HUGHES  
SERVICE INFORMATION  
LETTER

LETTER NO. L-47

SUBJECT: INTERIM REVISION(HMI) RE: WEAR TOLERANCES -  
P/N 269A5618 OUTPUT SHAFT, TAIL ROTOR TRANS-  
MISSION

MODELS AFFECTED: All helicopters equipped with P/N 269A5650 Tail Rotor  
Drive Transmission Assembly

FIGURE 1. WEAR TOLERANCE- OUTPUT SHAFT, TAIL ROTOR TRANSMISSION

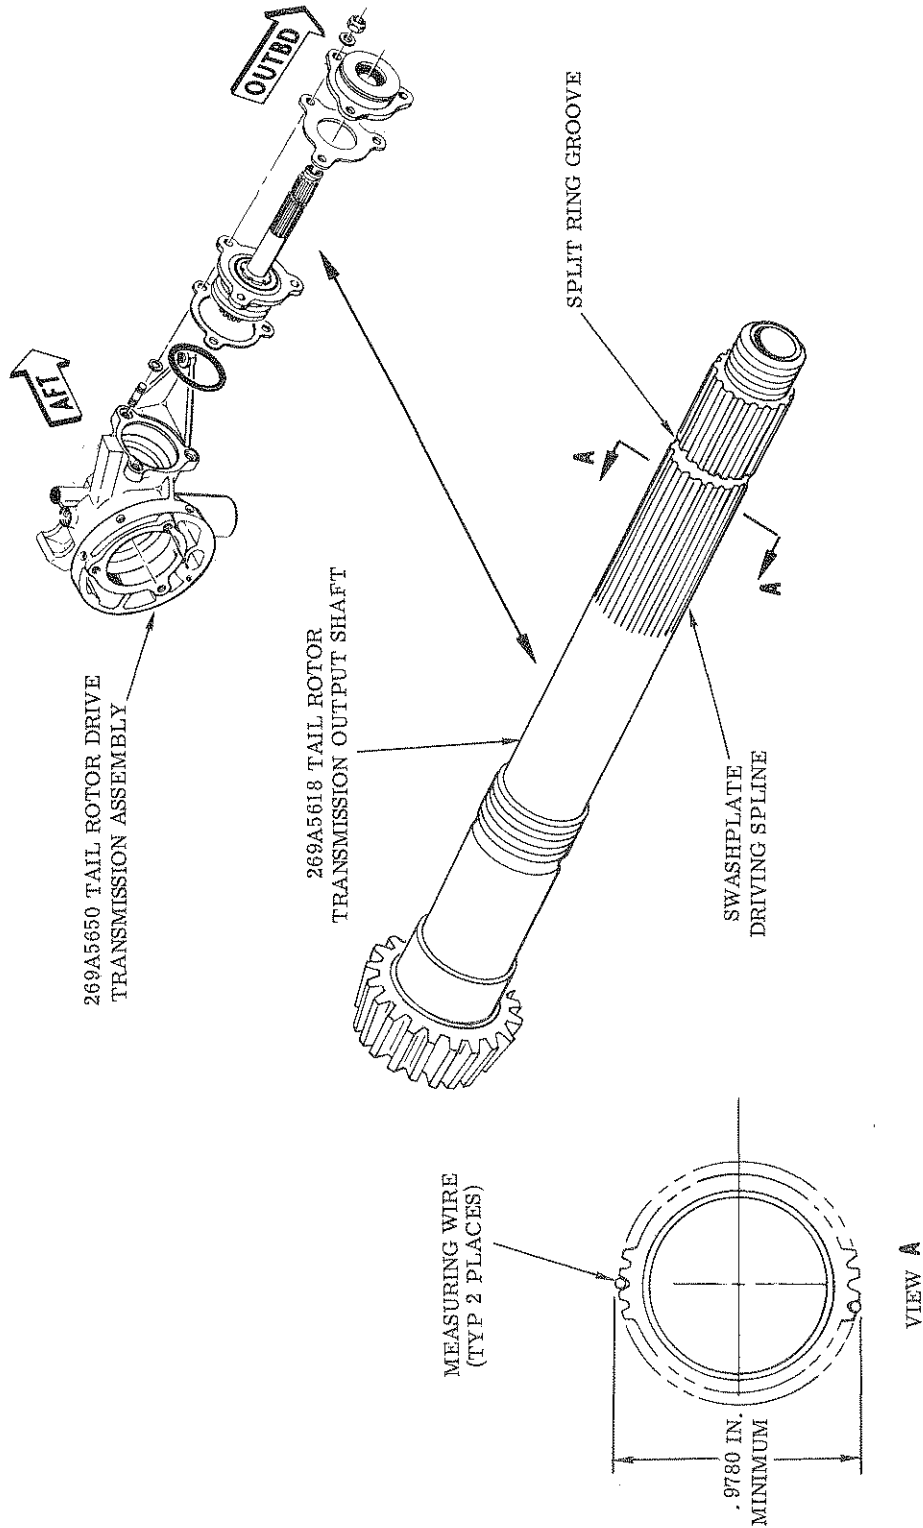
g. Inspect output shaft and spline teeth for excessive wear as follows:

(1) Insert two 0.0960 inch diameter measuring wires nearly opposite each other in tooth spaces between teeth of the swashplate driving spline inboard of the split ring groove, as shown in Figure 1.

Output shaft has odd number (17) of splines; therefore wires will not be spaced  $180^{\circ}$  apart.

(2) Position micrometer over two wires to obtain measurement; repeat through full circumference of spline.

Tooth wear shall be acceptable when dimensions are 0.9780 inches or above. If any measurement is below the 0.9780 minimum dimension, remove the output shaft from service.

(3) Using micrometer, measure diameter of pinion shaft; pay particular attention to oil seal contact area on shaft.

Wear induced by the oil seal on output shaft shall be acceptable to 0.9060 inch diameter, providing no oil leakage is observed. If wear induced by the oil seal on the shaft is in excess of the 0.9060 minimum dimension, or generates oil leaks, relocate the position of the seal lip on the shaft by inserting an additional gasket (20) under the seal retaining cap. (Refer to following paragraph, ASSEMBLY-TAIL ROTOR TRANSMISSION, Step c.)
